# Technical Notice

<b>Product Name:</b> SPCIE-C2260 series, SPCIE-C236-R10 series, PCIE-Q870-i2-R10 series, PCIE-Q170-R10 series, PCIE-H810-R10 series, WSB-H810-R10 series.	<b>Status:</b> Running change
---	----------------------------------

This notice is to inform you of the change on stiffeners of SPCIE-C2260 series, SPCIE-C236-R10 series, PCIE-Q870-i2-R10 series, PCIE-Q170-R10 series, PCIE-H810-R10 series, WSB-H810-R10 series.

**Product Name:** SPE-6S-R10

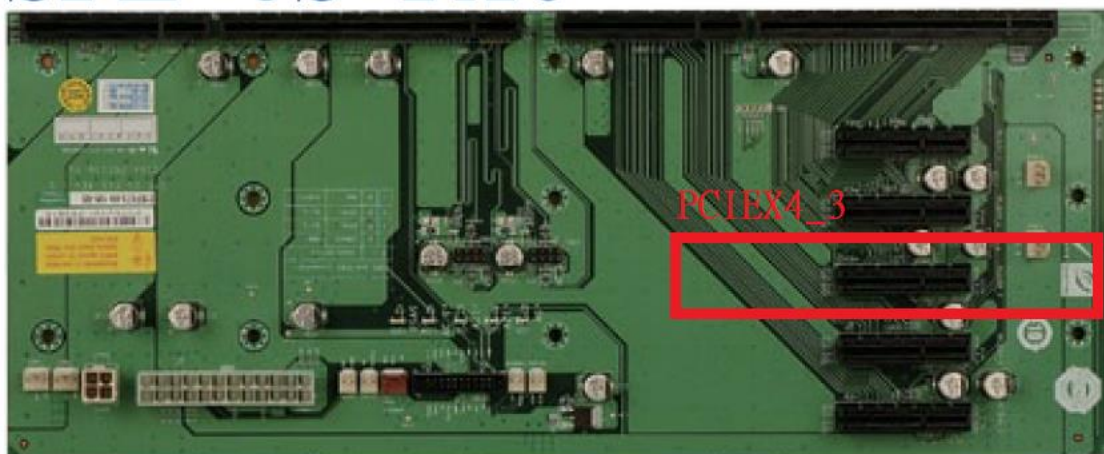
This notice is to inform you of the limitation of SPE-6S-R10 with SPCIE-C236, PCIE-Q170, HPCIE-C236 and HPCIE-Q170.

Due to the PCIE x16 of Intel® Xeon® E3v5 Family and 6<sup>th</sup> /7<sup>th</sup> generation Core™ processors only can separate to one PCIE x8 and two PCIe x4, and the chipsets, C236 & Q170, only can support one PCIe x4. PCIEX4\_3 on SPE-6S-R10 cannot work with SPCIE-C236, PCIE-Q170, HPCIE-C236 and HPCIE-Q170.

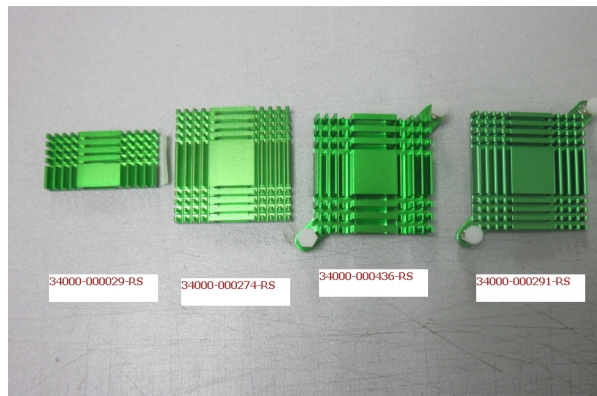
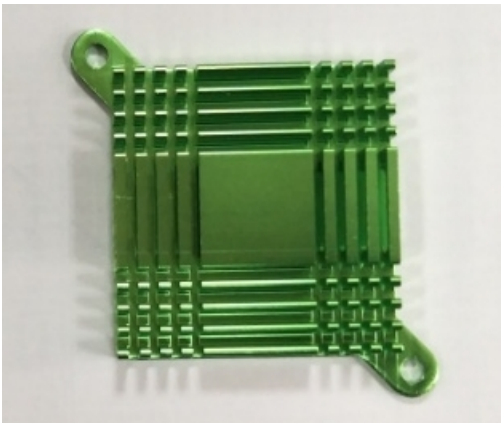
Due to the original dye vat is damaged after long term usage, our vendor change the new one for better quality.

Heatsink color change from grass green to light green.
